TITLE: Manual Service Disconnect Replacement**Type: Customer Satisfaction Campaign****Year: 2020****Applicability: MY20 Revero GT****System: Electric Drive****Market Region: All****Sequence: 01**

Purpose: There is a specification change in the Manual Service Disconnect (MSD). Replace the current installed unit in the vehicles listed on the following page.

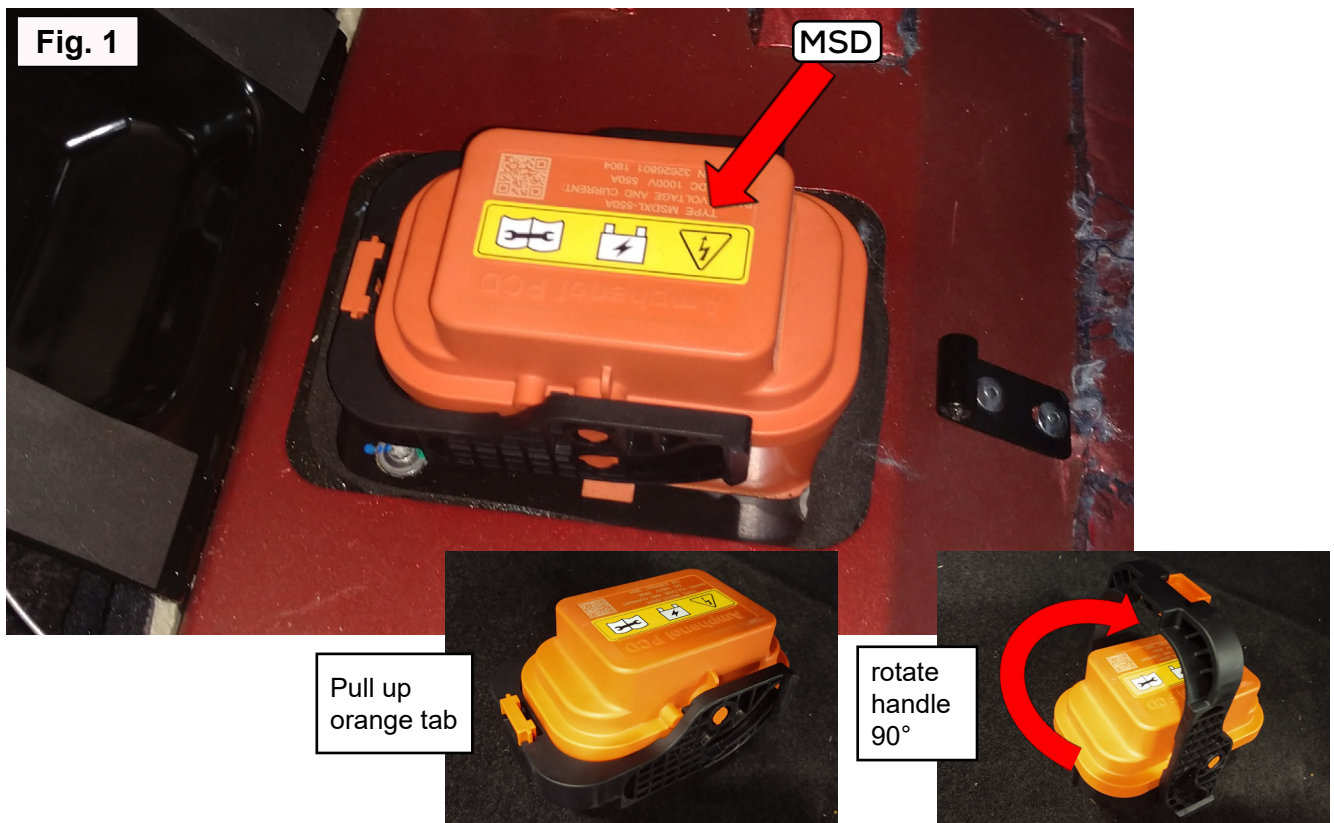
Disconnect the 12-Volt, remove the fuse #21 (BECM fuse) then remove the MSD, found under the rear LH (driver) side seat cushion. Replace with the new MSD, part number C131118006302, reinsert fuse #21, and reconnect the 12-volt.

The new MSD has a 400A rating.

Destroy the original MSD – with the MSD removed, drill a hole into the warning sticker.

Use the MSD part number C131118006302 during the diagnosis phase of the HV system repair, if needed, and replace the original MSD with a new unit after having completed the repair process.
